Service Bulletin N° 86

SUBJ: **INDEPENDENCE DAY** Potential Balltrap in the Plastic Under-Trough

Fig. 1

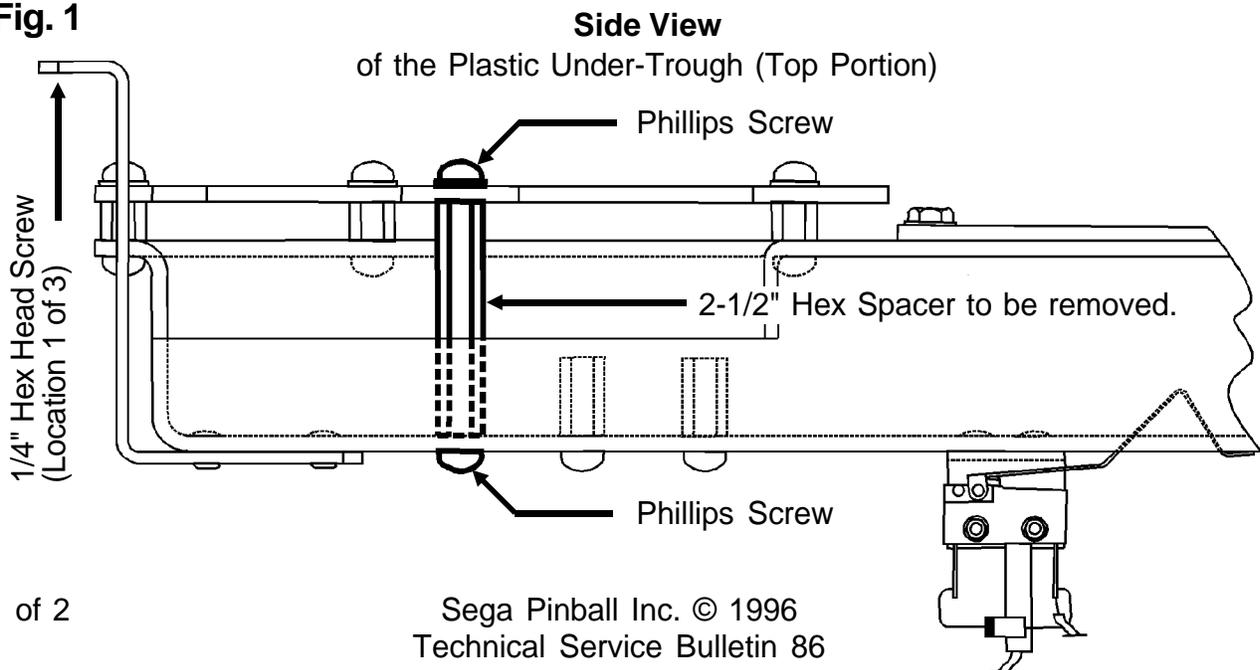
SYMPTOM: Balls get trapped in the Plastic Under-Trough Ramp beneath the *Alien Head*.

CAUSE: We have found a **potential** for a balltrap between the 2-1/2" Hex Spacer and the back wall of the Under-Trough because of normal variations in vacuum-formed plastic ramps (see Fig. 1 below).

SOLUTION: Remove the Plastic Under-Trough Ramp Assembly by removing the three 1/4" Hex Head Mounting Screws. Remove the two Phillips Screws and the 2-1/2" Hex Spacer (see Fig. 2 on the next page). Reattach the Under-Trough.

NOTE: This spacer was there strictly to give **additional** support to the clear plastic cover over the top of the trough. *Removing it will not create any problems.*
